Date	Name			
				Drawn	03.07.2018	voigt			
				Checked					
				Standard					
							Cube_30_with_35mm_hole <sup>1</sup>		
State	Changes	Date	Name					A4

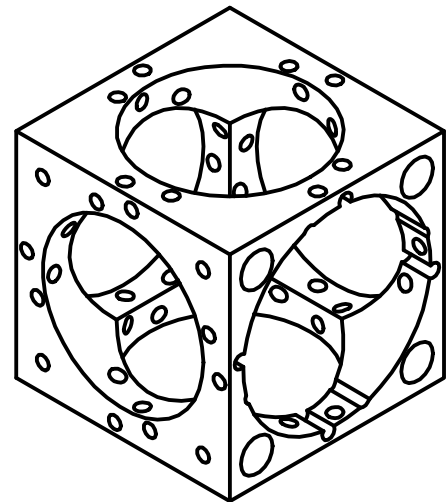
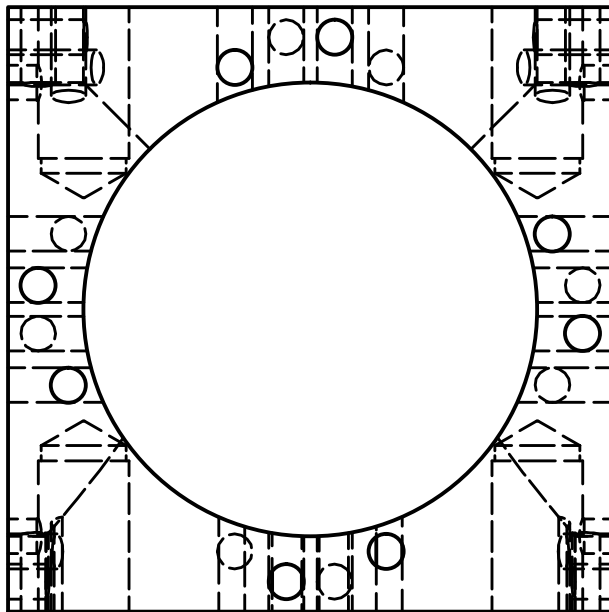
At a face of the cube with 4x openings for a 30 mm cage system:  
Widen the 30 mm hole to 35 mm  
(Radius 17.5 mm), depth: 15 mm  
Test fit with a 35 mm Qioptiq  
lens mount
